85 **PU-14-105** Filed: 7/13/2016 Pages: 6
Staff approval of request for windfarm site revisions

Submittal via email to ndpsc@nd.gov
Case Number: PU-14-105

Re: Sunflower Wind Project – Construction Site Access Road Adjustment

Attachment 1 - Turbine 28 Access Road Re-route

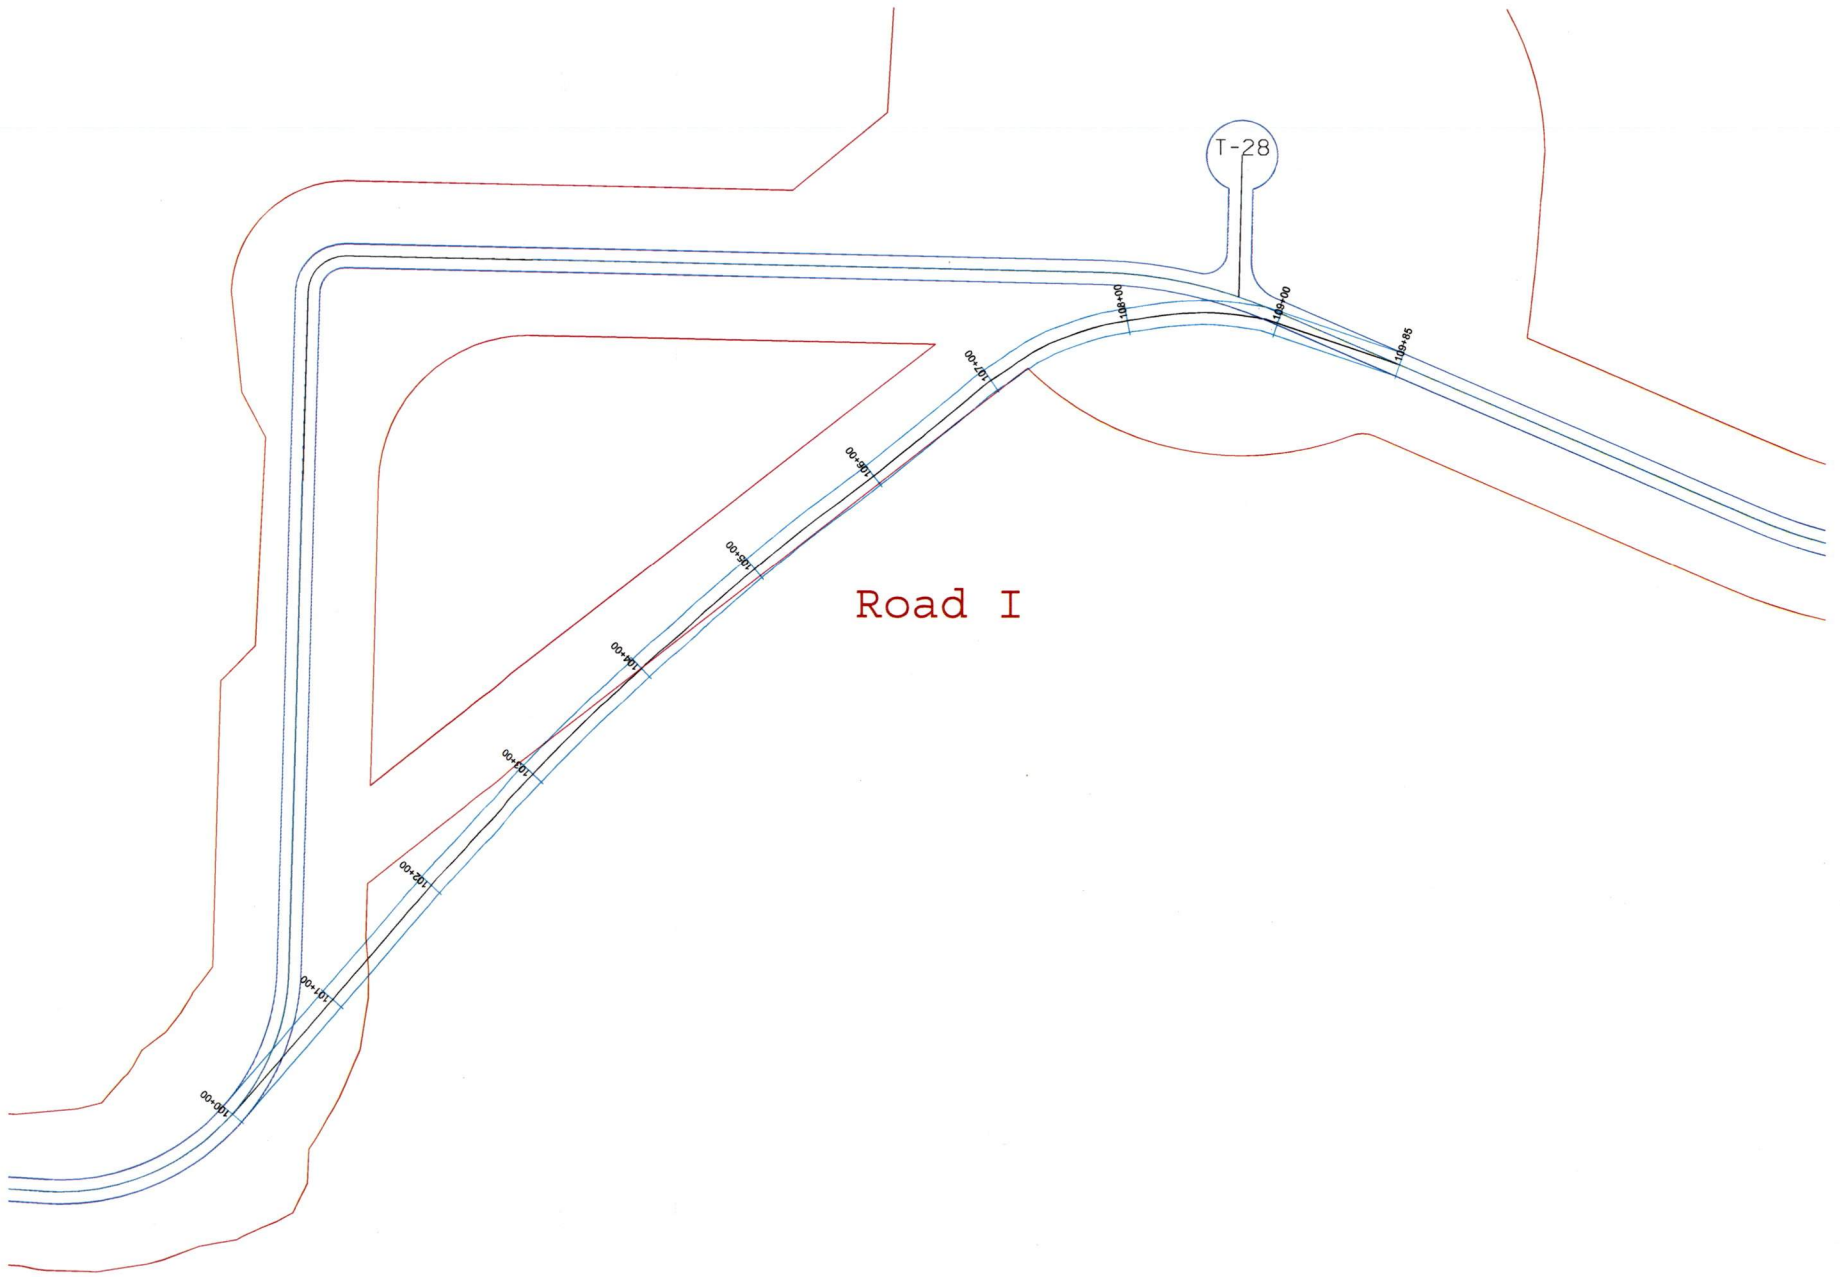
1. Reroute the access road leaving turbine site 28 to follow the collection system routing on higher ground rather than making the 90-degree bend into the low lying area (Attachment 1). This change has been approved by the landowner, remains within the culturally surveyed corridor and will not affect any exclusionary or avoidance areas.
2. Reroute the access road approaching turbine 39 to border the existing fence line rather than removing a portion of the existing fence (Attachment 2). This change is within the leased disturbance area, remains within the culturally surveyed corridor and will not affect any exclusionary or avoidance areas.

Please consider this email as staff approval of the site plan changes requested below and described in the attachment.
